Quible & Associates, P.C.

March 27, 2024

Re: Major Site Plan Application Resubmittal
Athletic Facility – 1559 Waterlily Rd
Coinjock, Currituck County, North Carolina

A copy of the TRC review comments dated March 12, 2024 (McAdams) and March 13, 2024, are enclosed for reference, and our responses listed below for ease of review:

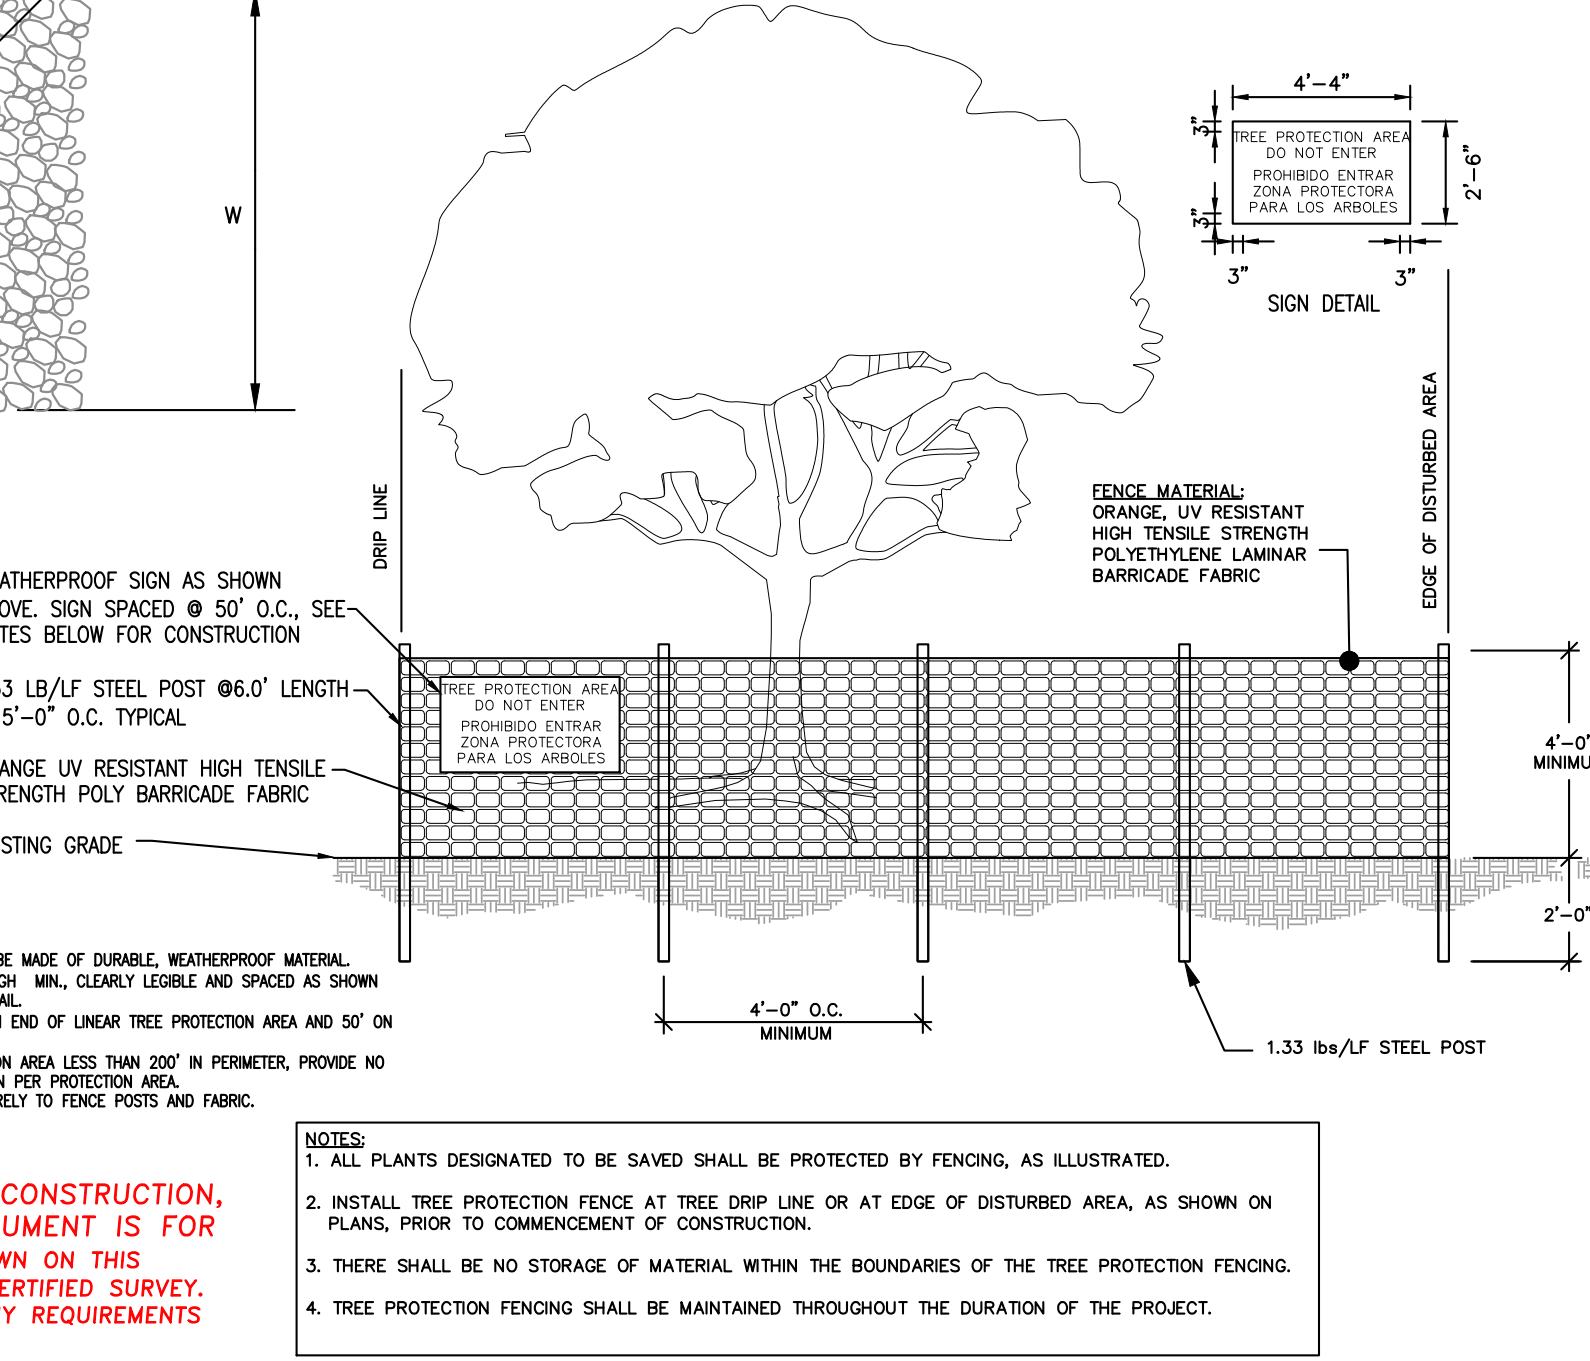
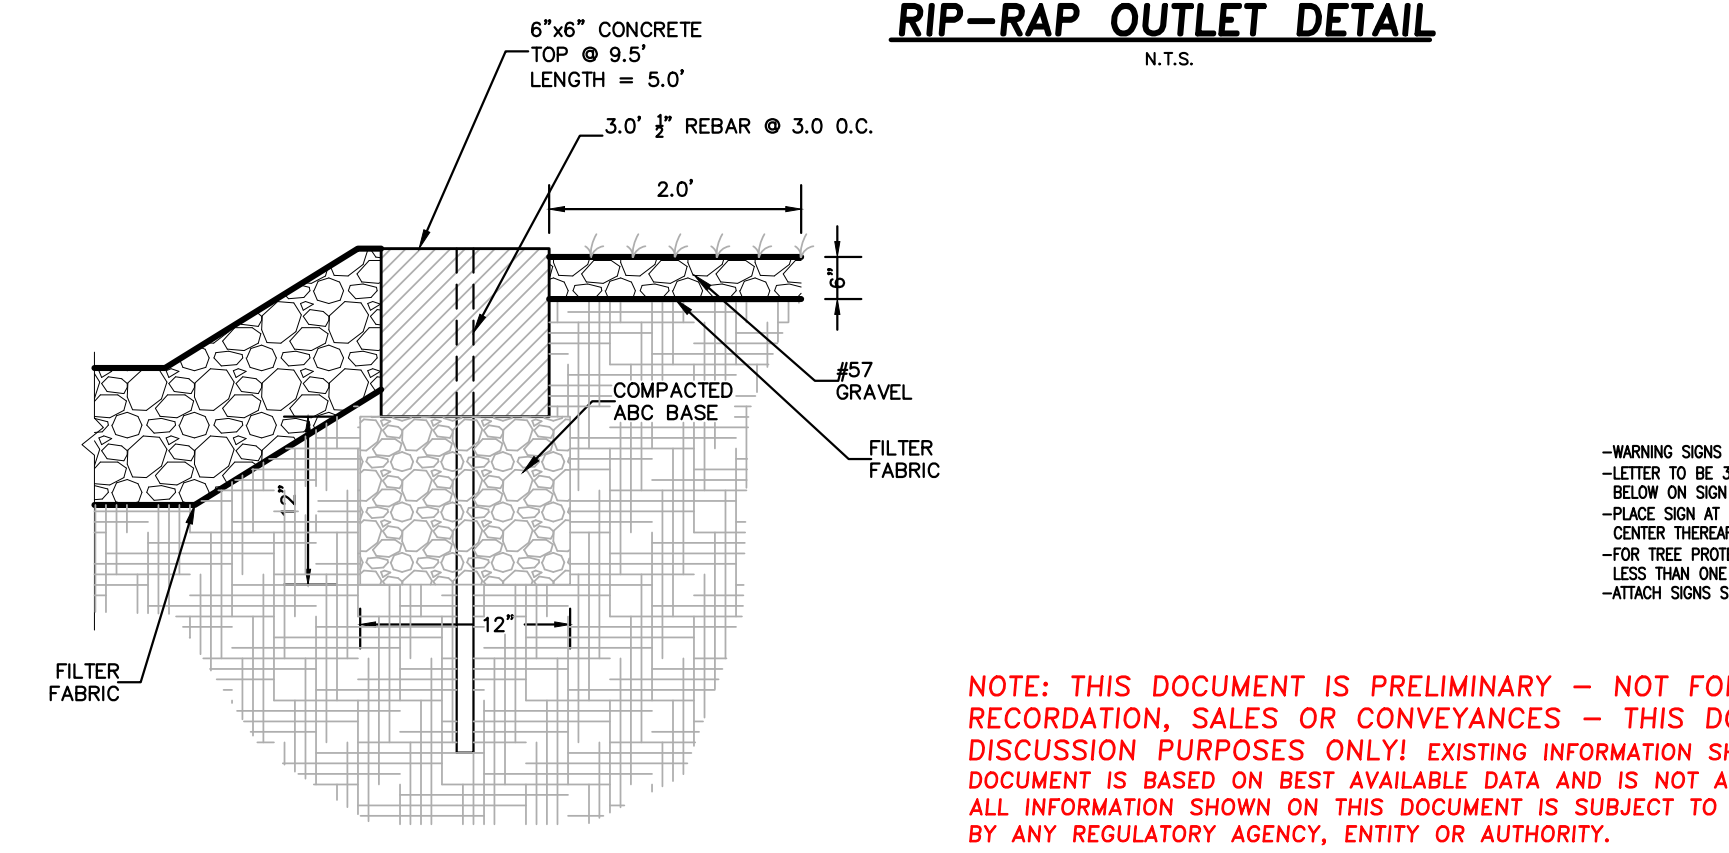
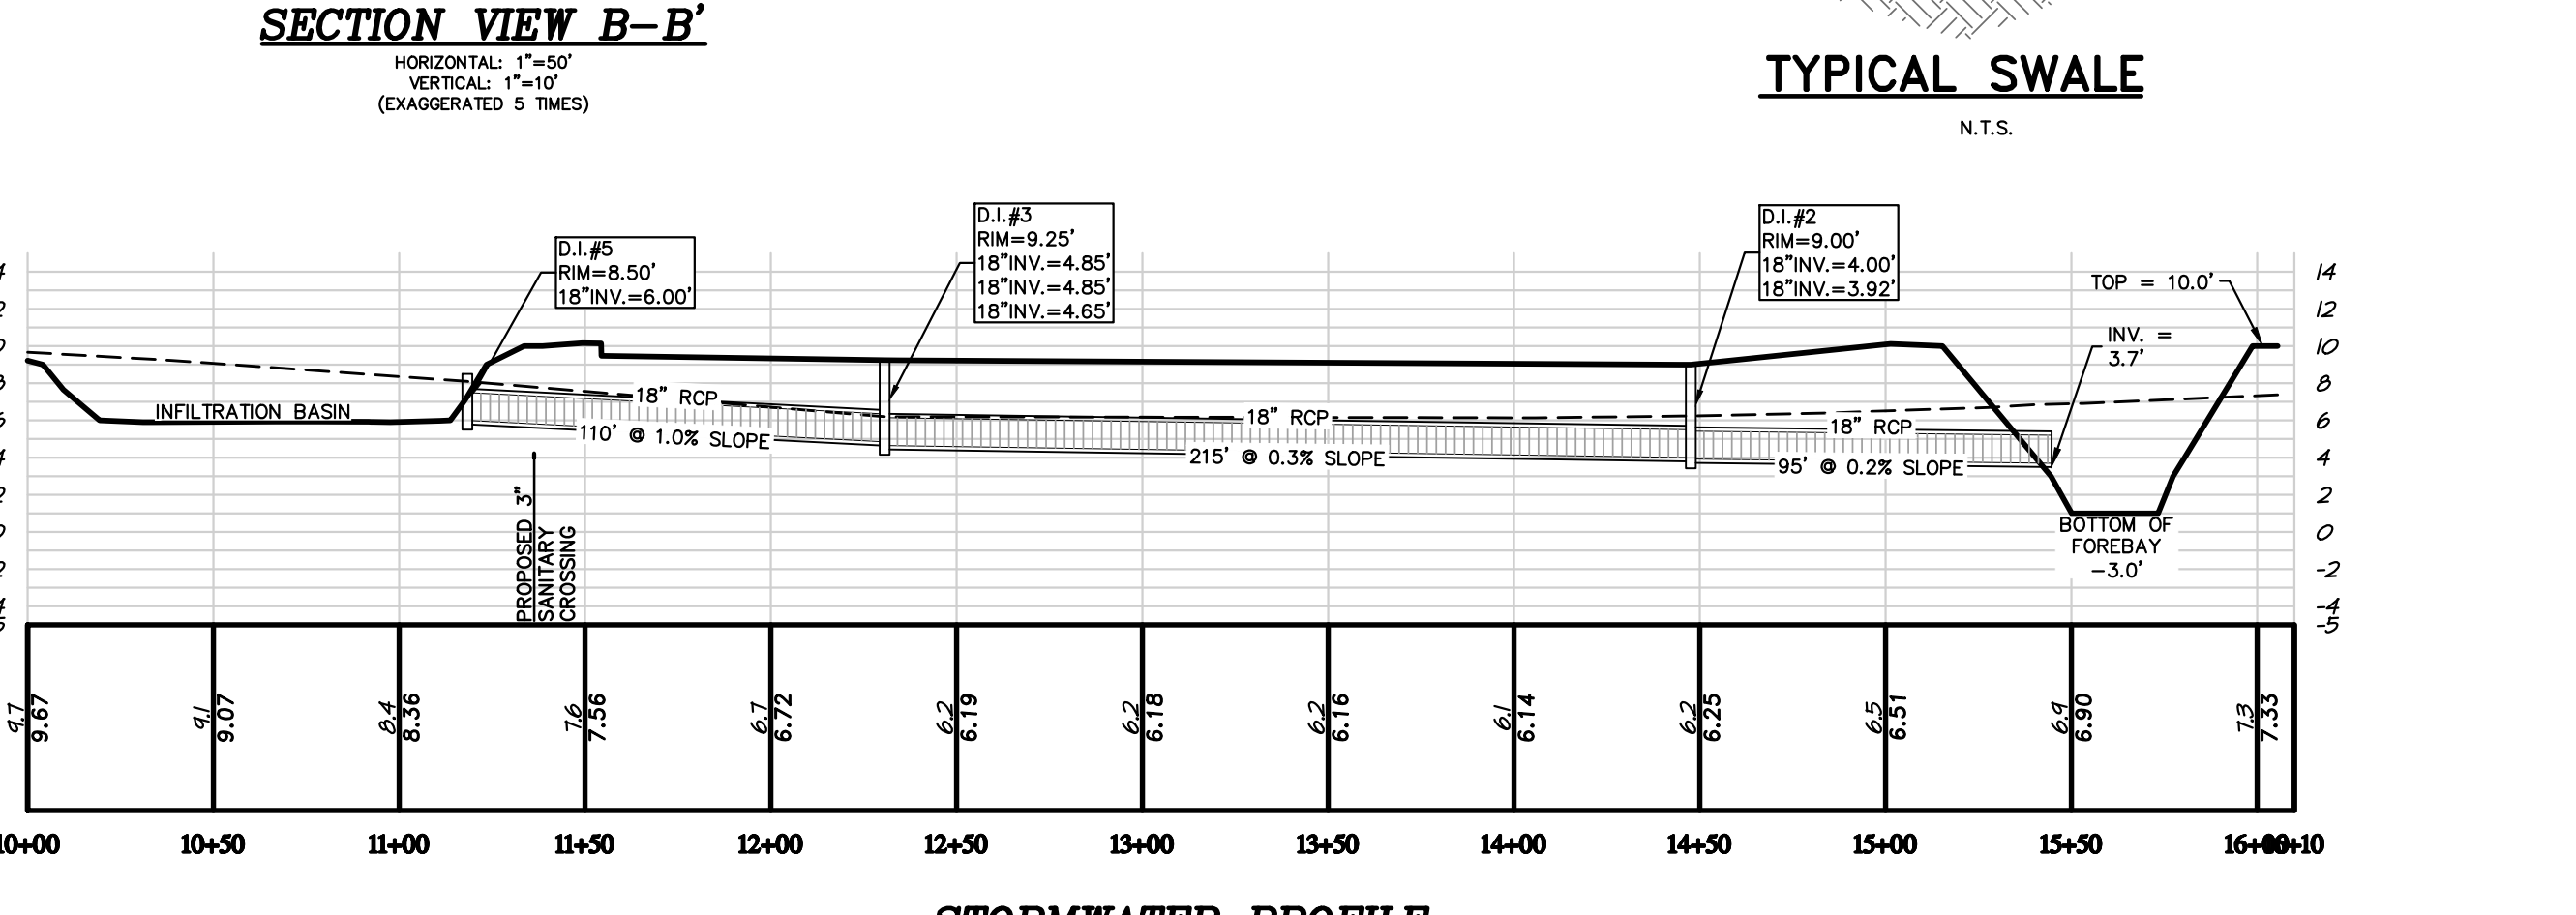
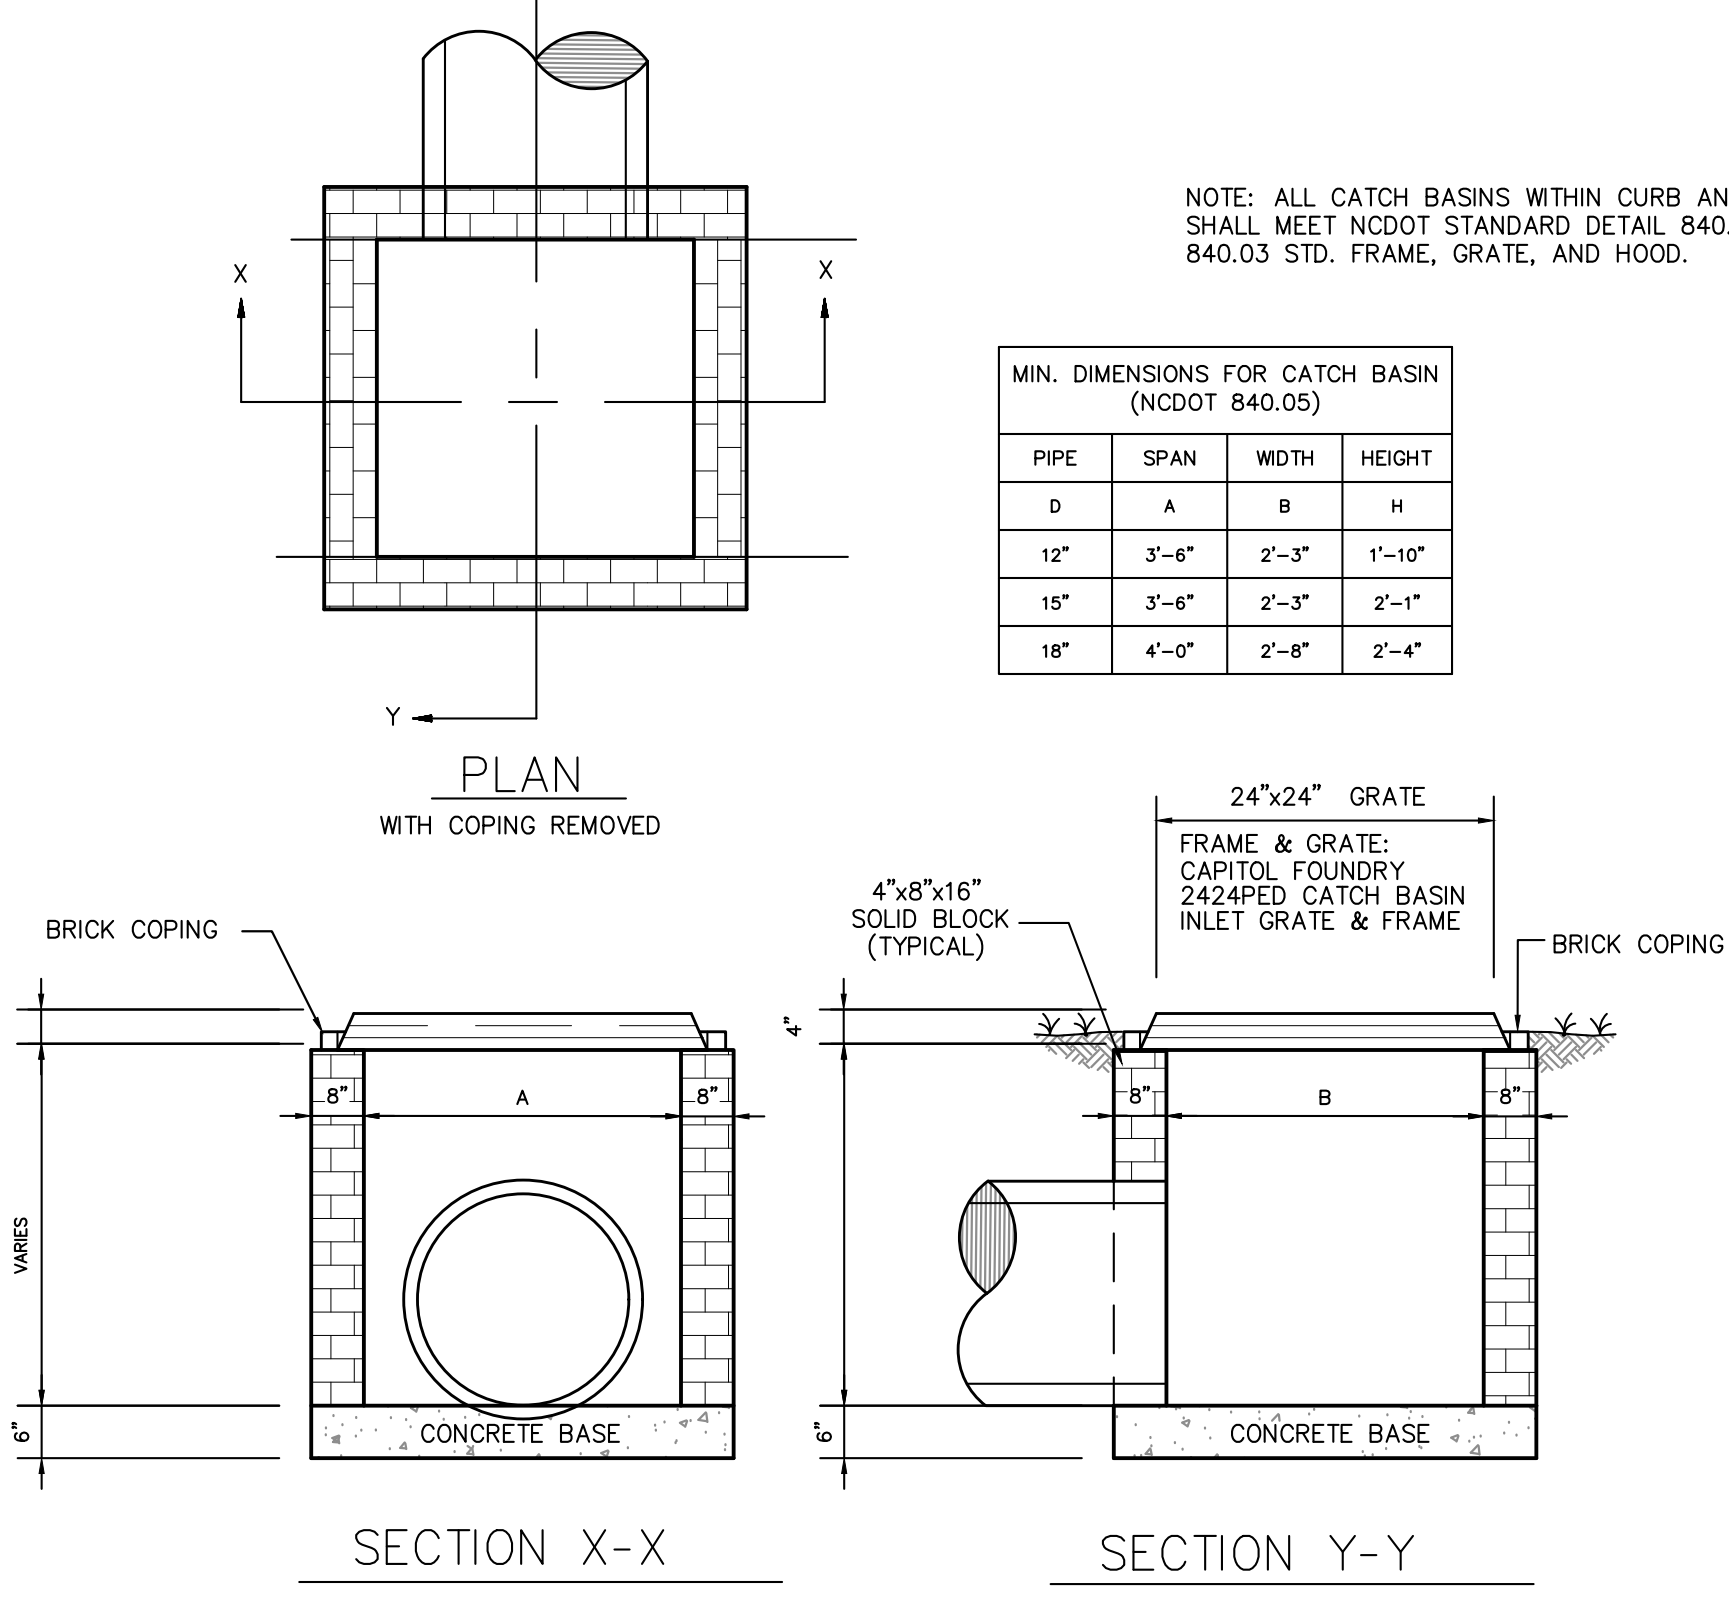
6. SESC Sheet #6 – Callouts for the wet pond detail do not match those in the plan view on Sheet #5. Correct slope call out to more accurately reflect the proposed design. *Acknowledged. This detail has been updated.*

7. SESC Sheet #6 – Callout downstream invert elevation of pipe network to the wet pond forebay. *Acknowledged. This invert has been updated.*
8. SESC Sheet #6 – Outlet structure detail call outs don't match those listed on the plan view, specifically pipe invert elevation and size. *Acknowledged. The inverts in plan view have been updated to match the outlet structure detail and a downstream swale is now shown.*

9. SESC Sheet#6 – SHWT and Permanent Pool Elevation are defined as 3.5' in this detail. SHWT is defined as 3.7' throughout the rest of the report. These values should match for
